John G. Haggard, Manager
Hudson River Program

RE: Hudson River PCBs Superfund Site: Baseline Modeling Report Peer Review

Critical Issues Imbedded in Fate and Transport Model Peer Review Charge Question 11

Comparison of GE model computed cohesive sediment burial rates in Low Resolution Coring Analysis Cluster Area 14 and in the larger area represented by Segment 8 of the EPA Hudtox Model

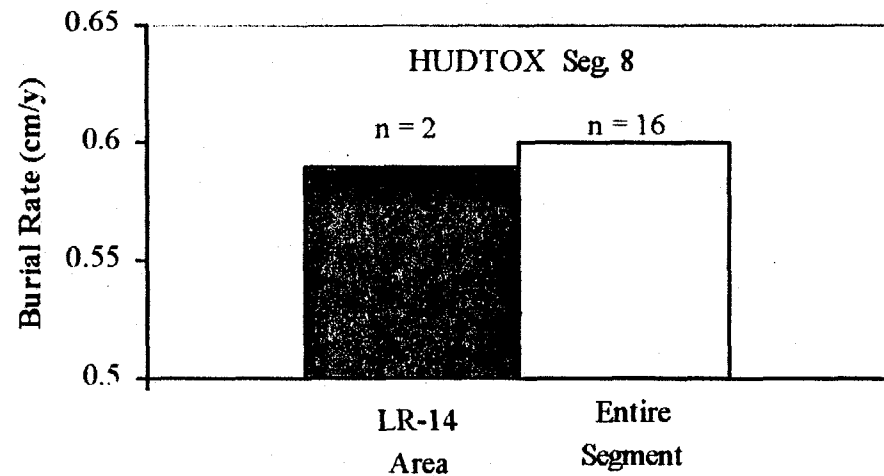
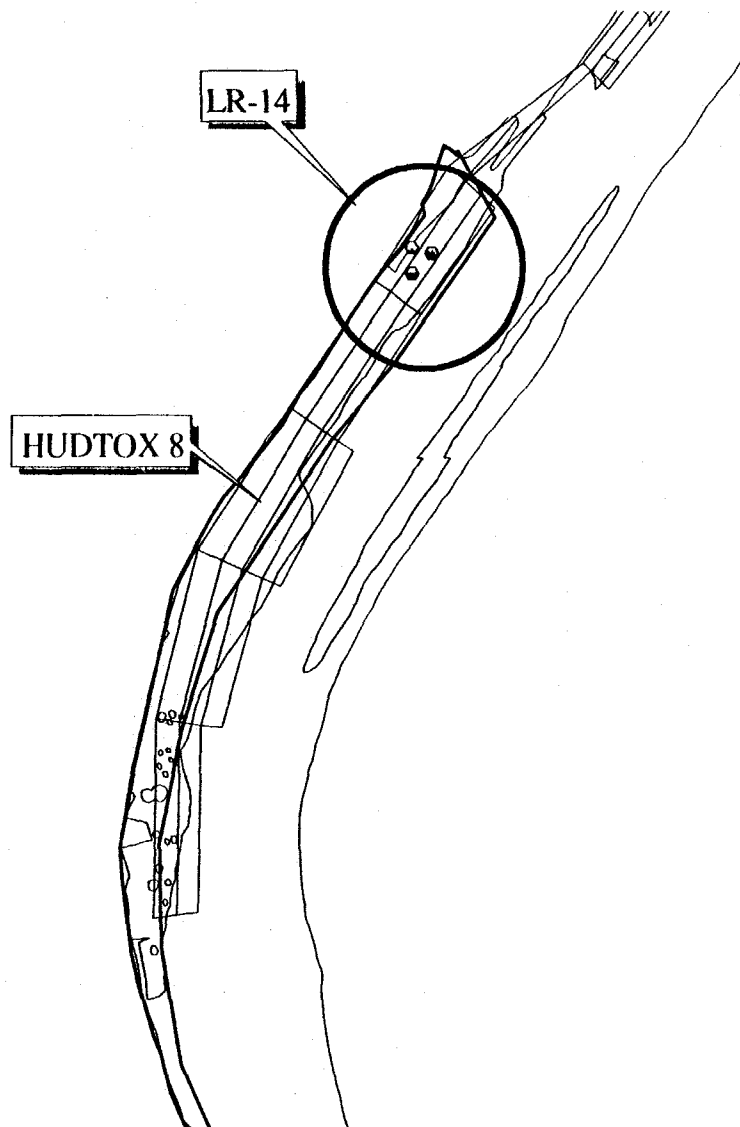
EPA has made no attempt to determine whether such deviation exists. Such a determination can be made using the EPA hydrodynamic and sediment erosion model, which has spatial resolution comparable to, or finer than, that of the geochemical analysis (see Figures 3-2 and 3-3 of the RBMR; USEPA, 2000). The General Electric hydrodynamic and sediment transport model, whose results were used by EPA in calibrating its model, also has sufficient resolution to examine conditions on the scale of the geochemical analysis. As shown for each of the 1994 sampling clusters on which the geochemical analysis relies (see attached figures), the GE model indicates that the targeted locations are **not** erosional and tend to have greater deposition rates than the averages for the larger areas represented by the HUDTOX model.
